# NextEra Energy Transmission West and Pacific Gas and Electric Company Estrella Substation and Paso Robles Reinforcement Project Proponent's Environmental Assessment (A.17-01-023)

## Response to Deficiency List No. 2

**Exhibit 2-12. Potential Oak Tree Removal Locations Map**

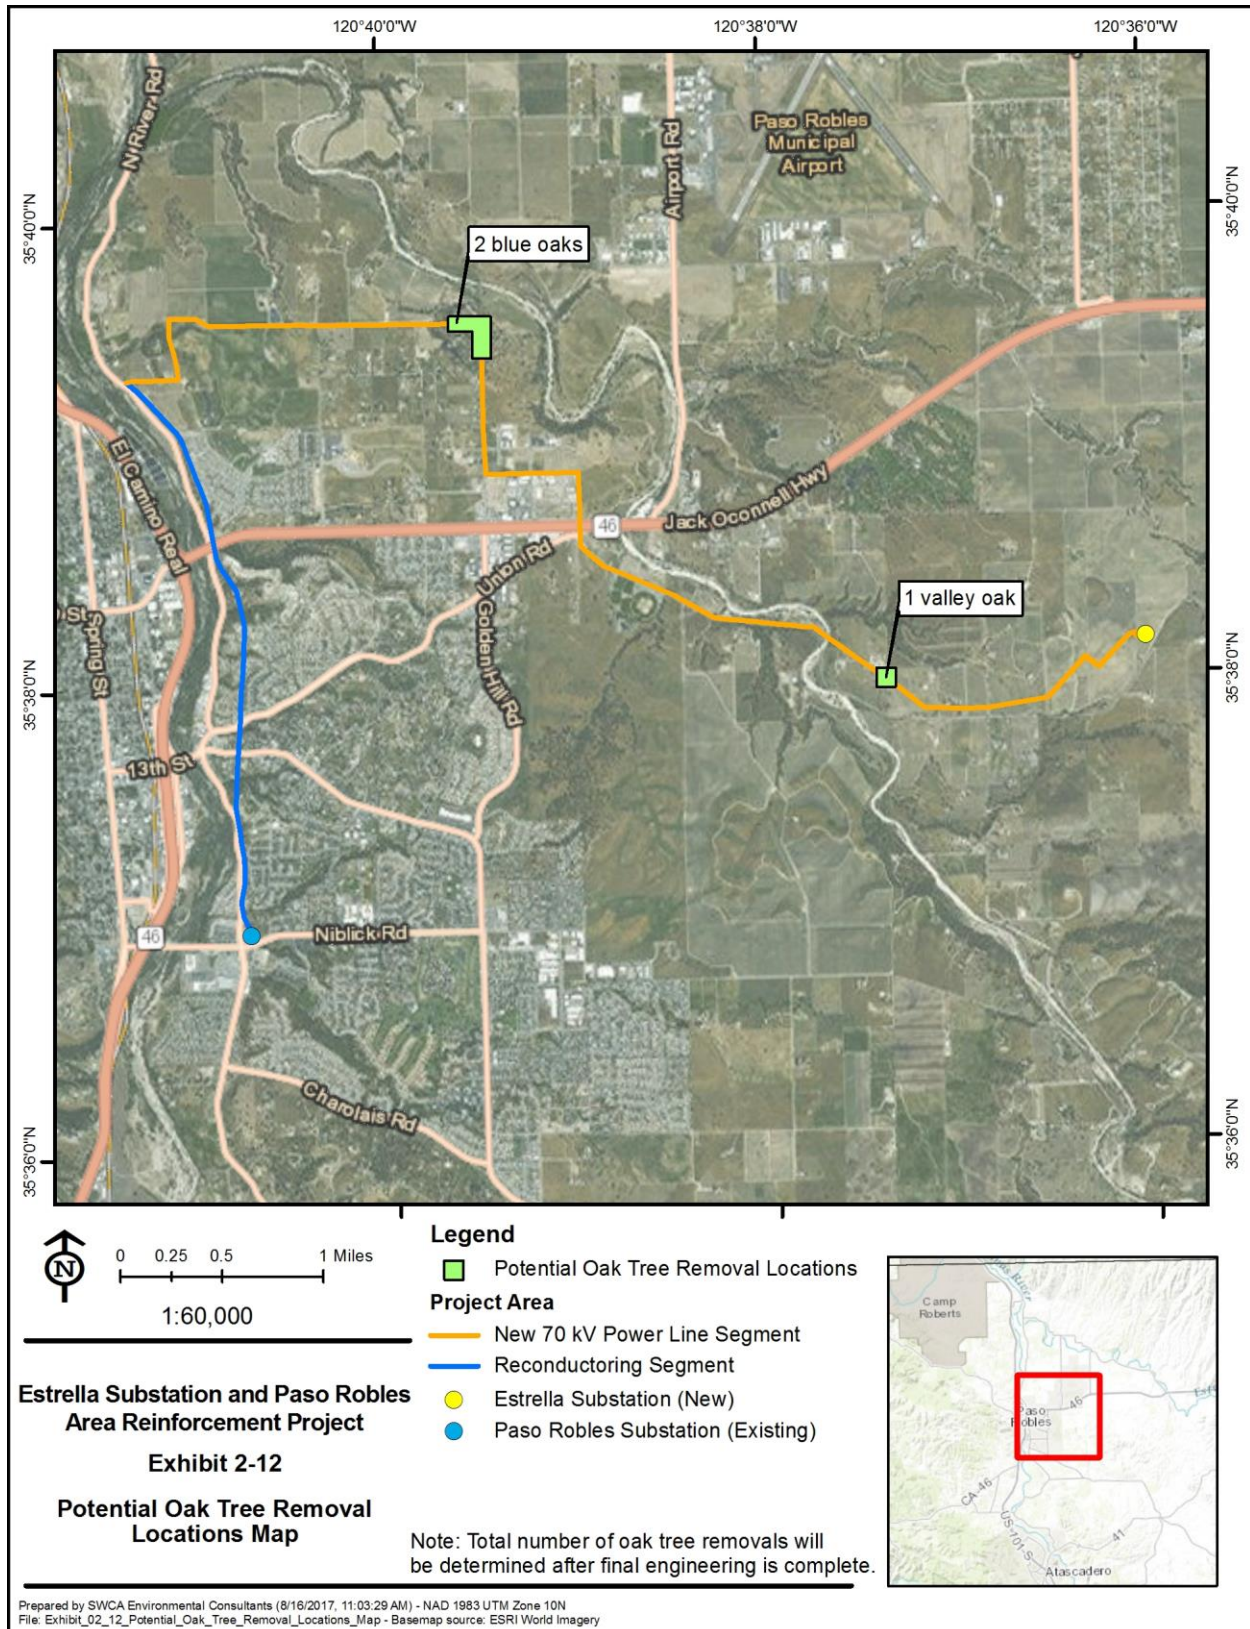
*The PEA indicates that three oak trees would be removed; please indicate on a GIS-based map where these oak trees are located. Later, the PEA states that additional oak trees may be removed. Please clarify the number and location of additional oak trees that may be removed.*

The PEA states on page 3.4-59 that up to three oak trees may need to be removed to construct the project. In particular, one valley oak tree and two blue oaks trees may be removed to construct the new 70 kV power line segment. The locations of the three oak trees currently identified for potential removal are shown on Exhibit 2-12, Potential Oak Tree Removal Locations Map. It is difficult at present to estimate the number and location of additional oak trees that may be removed or trimmed, if any, at the time of construction because the project design is preliminary and subject to change due to agency requirements and other factors, and conditions on the ground at the time of construction may be different than when the PEA was submitted (e.g., oak trees grow over time and property owners may trim or remove them).

PEA Figure 2-4. Estrella Substation Site Overview Map

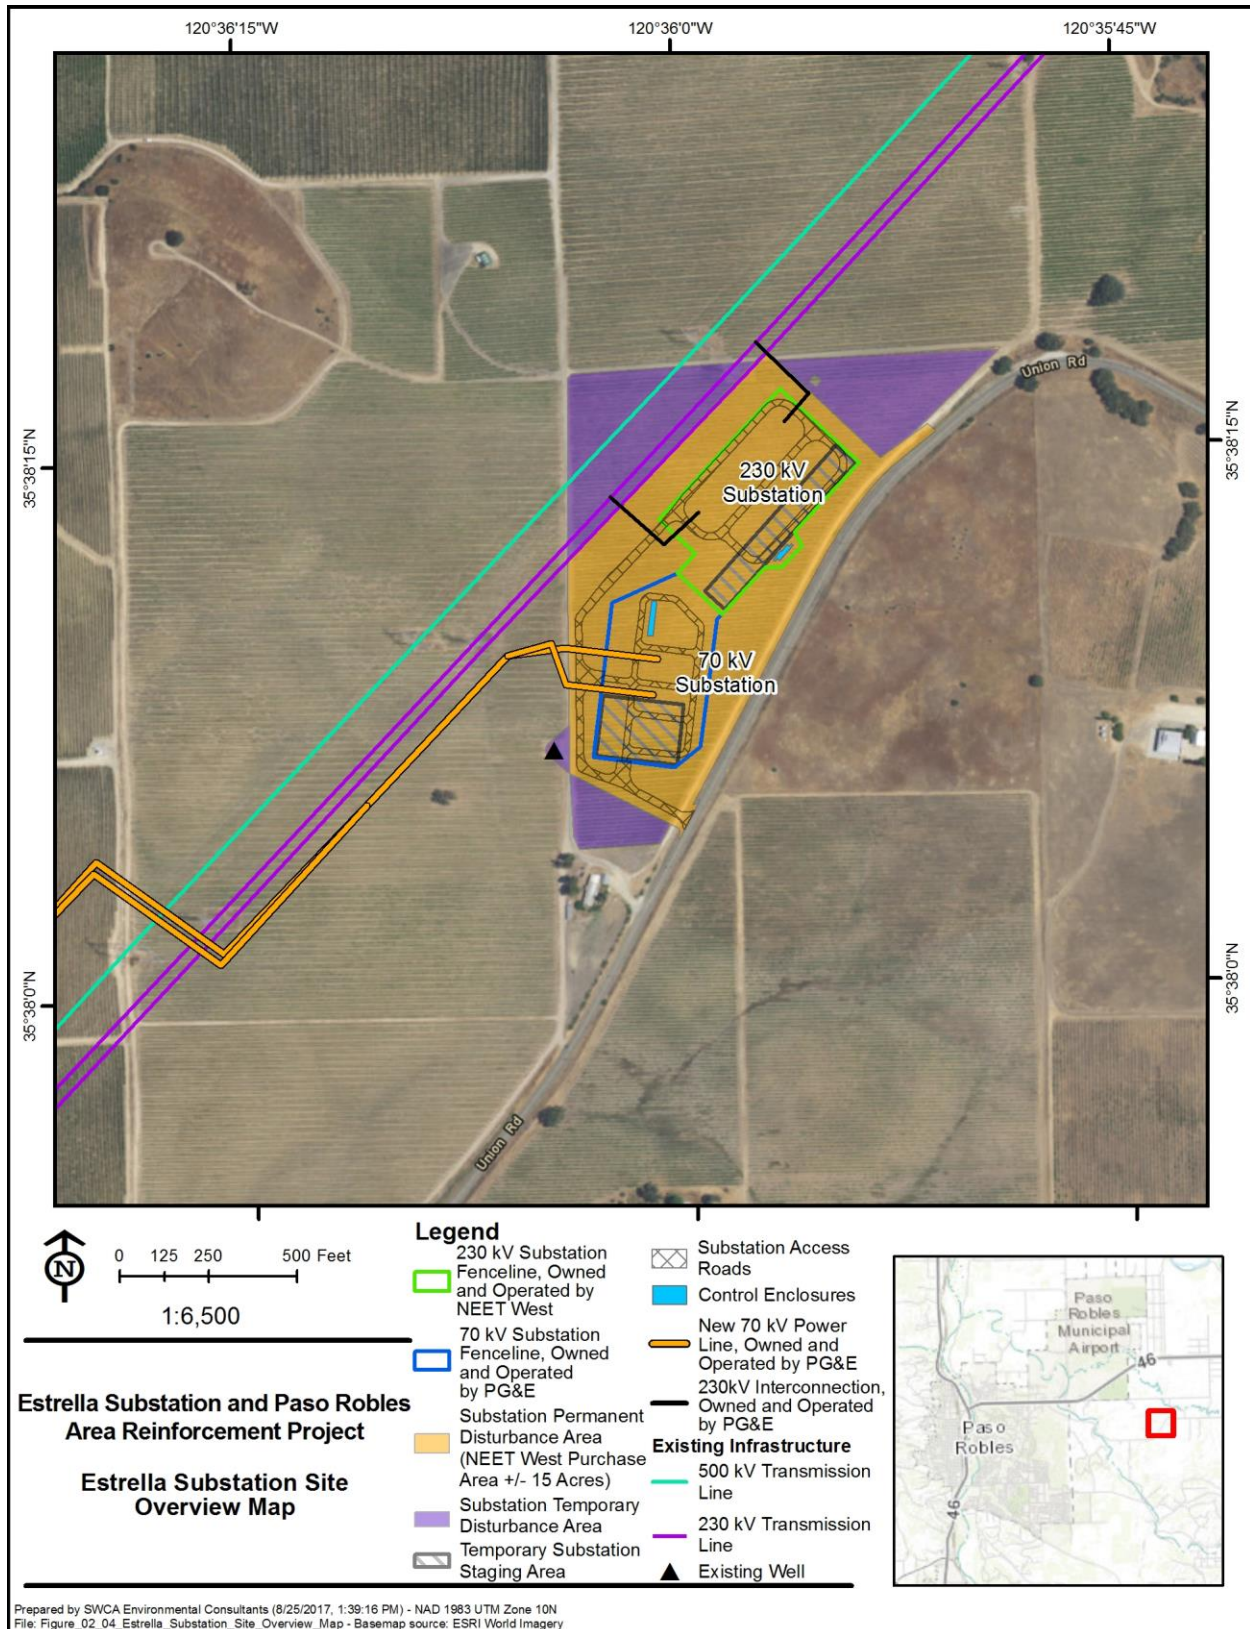
*Provide an updated version of Figure 2-4 that identifies ownership (i.e., PG&E or NEET West).*

*Update the figure to show full build-out (e.g., second 230/70-kV transformer pad).*

As described in the response to Deficiencies 20 and 21 on the PEA Deficiency List No. 1, the design of the “full substation build-out,” referred to by applicants as “ultimate” build-out, is not yet known, but space has been reserved in the substation to preserve the option of future expansion. Because ultimate substation build-out is not planned, designed, or reasonably foreseeable, its impacts are speculative and not analyzed in the PEA. The 230 kV substation will be owned and operated by NEET West. The 230 kV transmission line interconnection, 70 kV substation, new and reconducted 70 kV power line, and future distribution facilities will be owned and operated by PG&E.

PEA Figure 2-4 (Estrella Substation Layout) in Chapter 2, Project Description, has been updated below to show ownership of the substation facilities. For the proposed project, NEET West is proposing to purchase the portion of the parcel illustrated in gold in Figure 2-4. The exact ownership of the property for the remainder of the parcel to be purchased and the property lines between the NEET West and PG&E facilities have yet to be determined. The property lines will be determined once the project is approved. Per the PEA Checklist, the purpose of this figure is to show the geographic location of the project. Please refer to PEA Figures 2-5 through 2-10 for the speculative ultimate substation build-out.

**PEA Figure 2-5a. Estrella Substation Layout Showing Foreseeable Distribution Facilities**

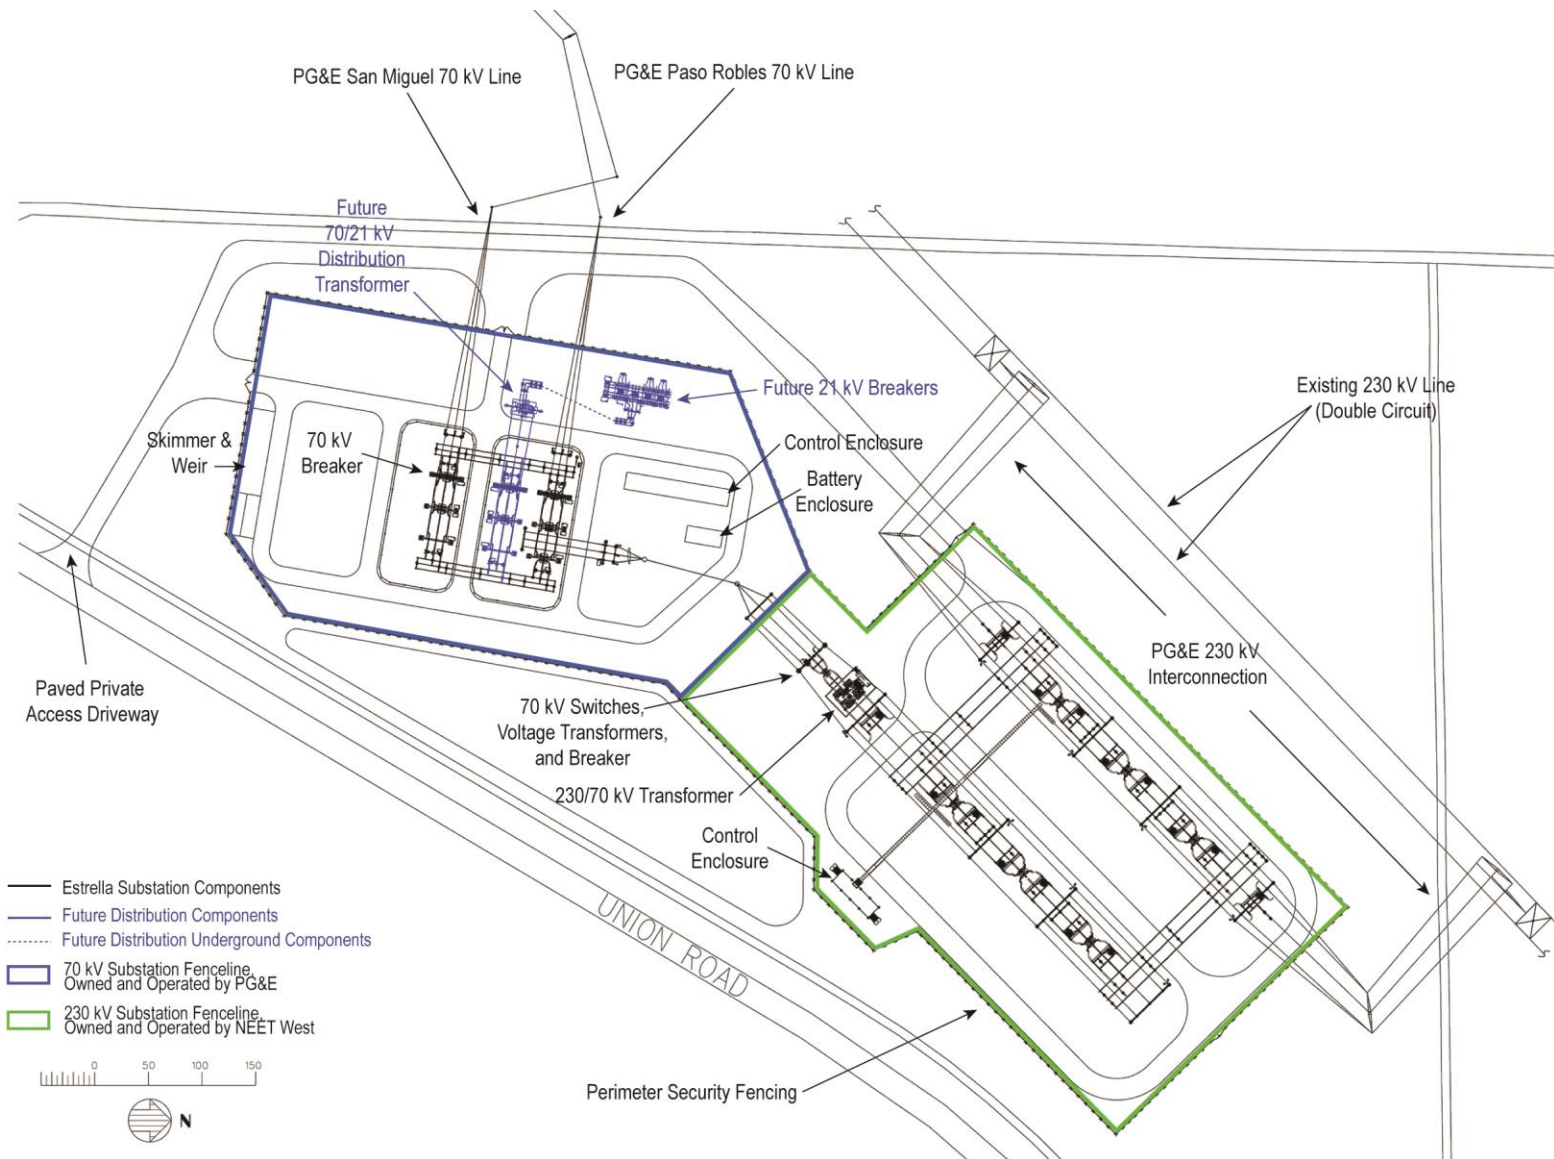
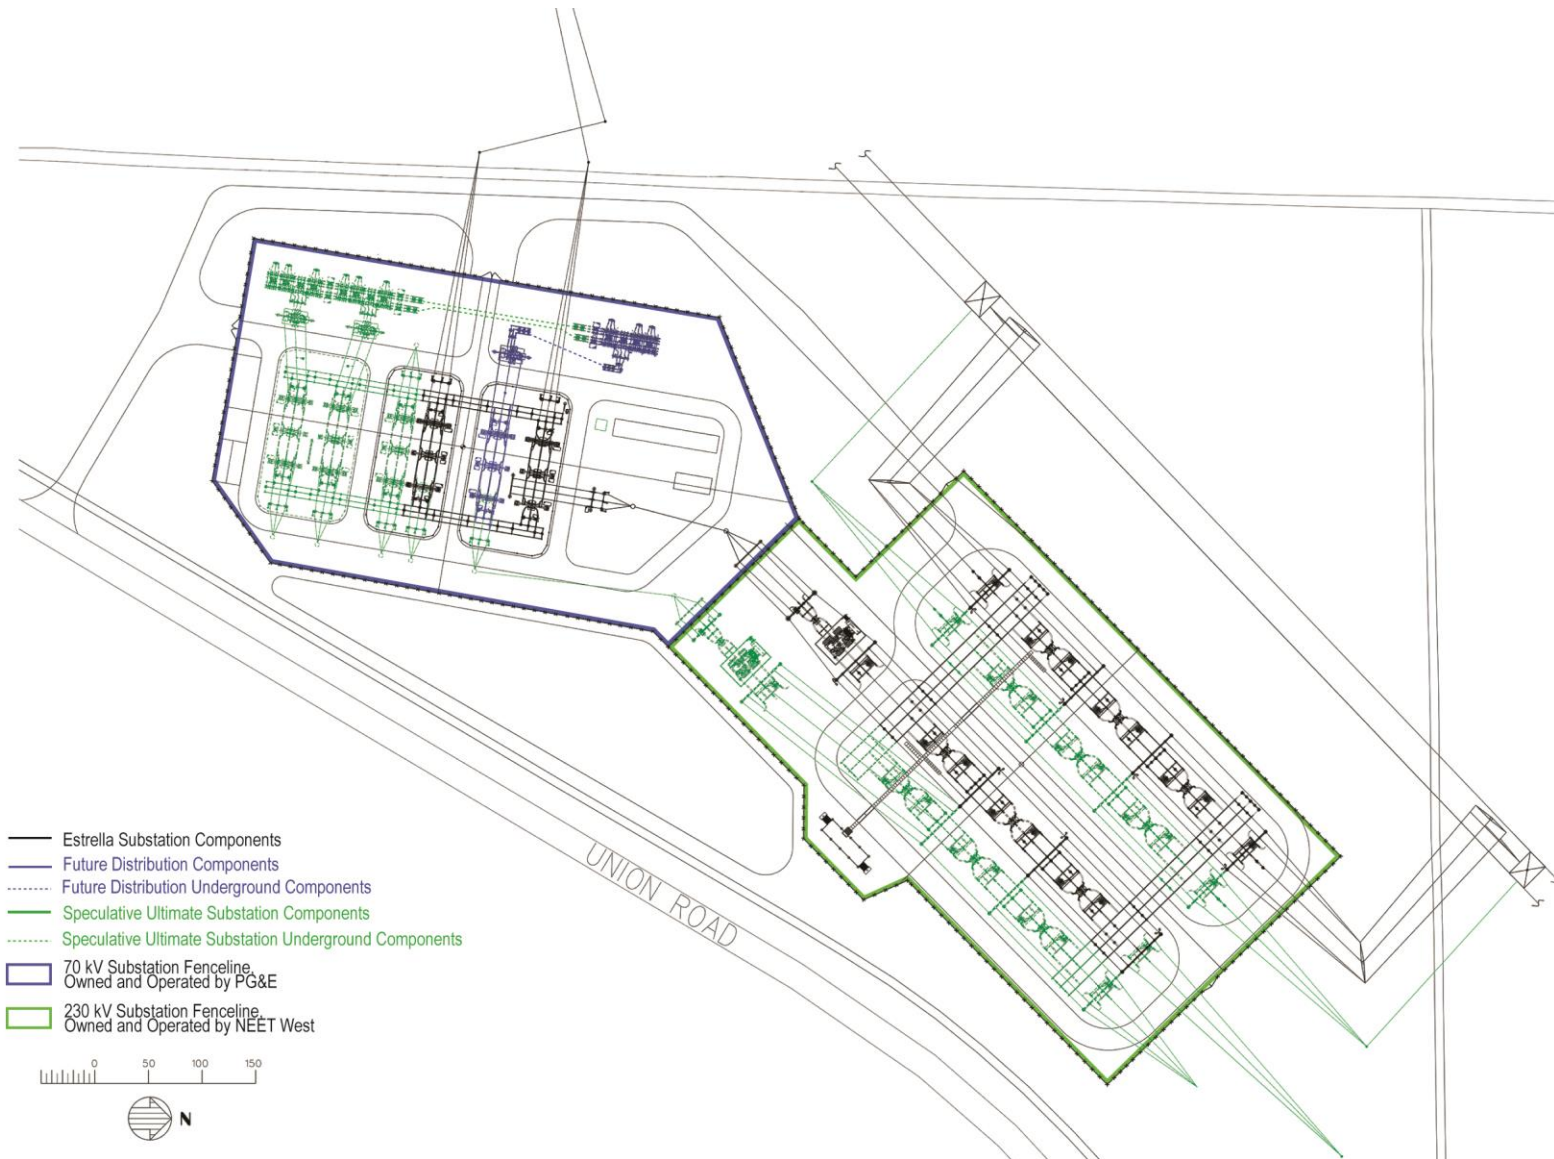
a. Provide an updated version of Figure 2-5 that shows the full substation build-out. Estimate where facilities would likely be located. Use a color or other means to indicate future/estimated build-out. Label the added full-build-out facilities (i.e., future 230/70-kV transformer and associated breakers and switches, three future 70/21 kV transformers and associated 70-kV breakers, 21-kV breakers, and switches). Identify the future 230-kV transmission tie-line alignments.

b. Identify facility ownership (i.e., PG&E or NEET West) by color.

As described in the response to Deficiency 2-18 above, since the design of the ultimate substation build-out is not yet known and is not planned, designed, or reasonably foreseeable, its impacts are speculative and not analyzed in the PEA. The 230 kV substation will be owned and operated by NEET West. The 230 kV transmission line interconnection, 70 kV substation, new and reconducted 70 kV power line, and future distribution facilities will be owned and operated by PG&E.

PEA Figure 2-5 was updated in the Revised PEA to show Estrella Substation with the planned future distribution facilities, including one transformer and three feeders. In response to Deficiency 2-19, the applicants have further updated PEA Figure 2-5 to identify facility ownership (see Figure 2-5a below), and to provide a speculative overview of a potential ultimate build-out that includes a future 230 kV transmission interconnection, a future 230/70 kV transformer with associated breakers and switches, and three future 70/21 kV transformers with associated 70 kV breakers, 21 kV breakers, and switches (see Figure 2-5b below). Current technology is assumed for purposes of the illustration.
